MIL "ON" DTC P26CB71

Service Category Engine/Hybrid System

Section Engine Control

YEAR(S)	MODEL(S)	ADDITIONAL INFORMATION
2018	Camry

Figure 1. Location of Authorized Modification Label on 2018 Camry

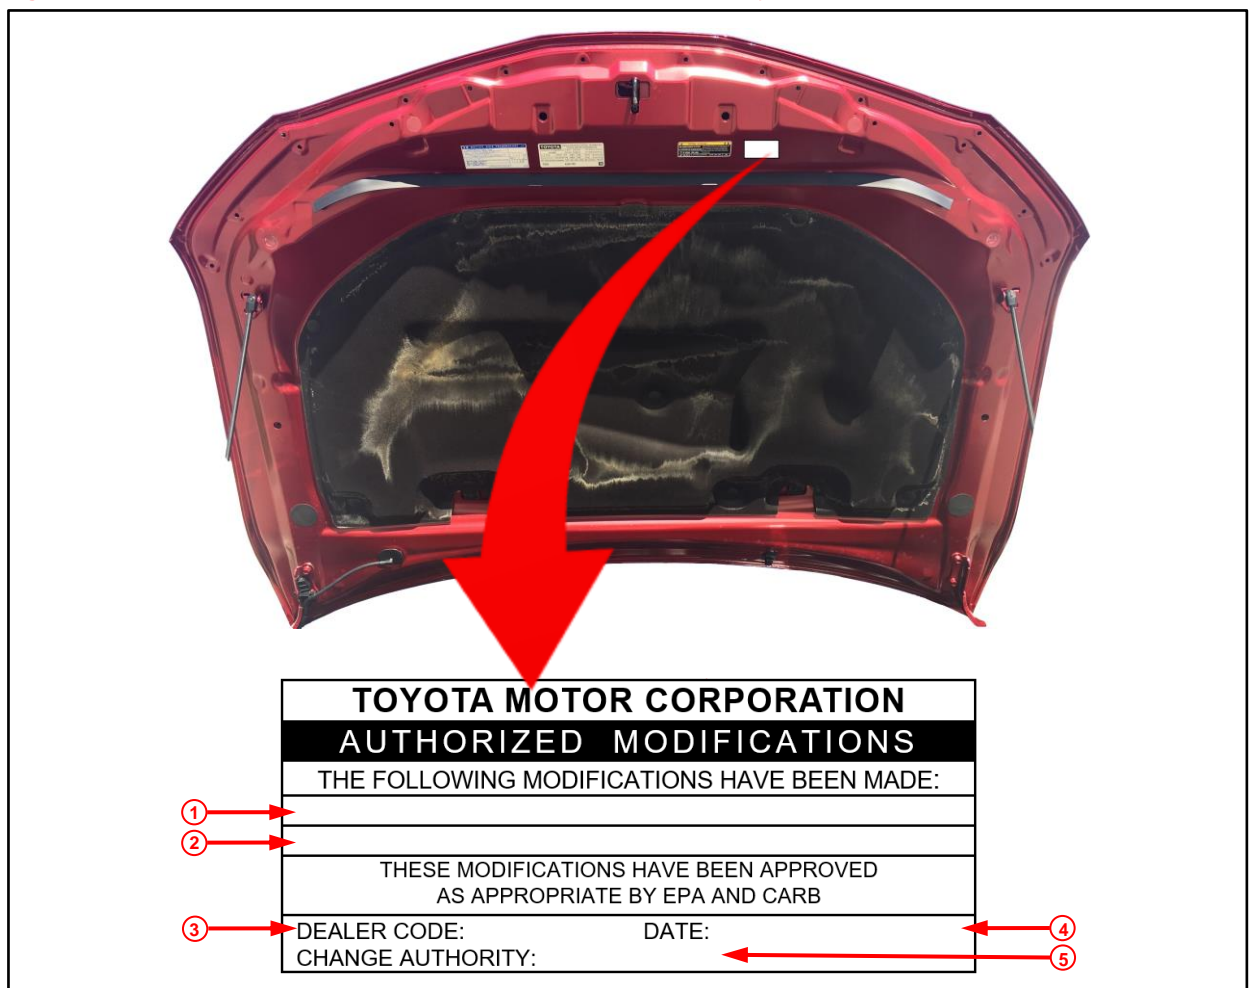
2. Check for the Authorized Modification Label affixed to the vehicle in the location shown below. Confirm if the ECM (PCM) calibration has been updated. Is the calibration ID listed the latest ECM (PCM) calibration?
 - **YES** — This bulletin does NOT apply. Continue diagnosis using the applicable Repair Manual.
 - **NO** — Continue to step 3.

- Prepare and install the Authorized Modification Label.
 - Using a permanent marker, enter the following information on the label:
 - ECM part number [Refer to the **Parts Information** section for the **NEW PART NUMBER**]
 - Calibration ID(s) [Refer to the **Calibration Information** section for the **NEW CALIBRATION ID**]
 - Dealer Code
 - Repair Date
 - Change Authority [**This bulletin number**]
 - Install the Authorized Modification Label on the vehicle at the location shown in Figure 1. The Authorized Modification Label is available through the MDC, P/N 00451-00001-LBL.
- Test drive the vehicle to confirm proper vehicle operation.
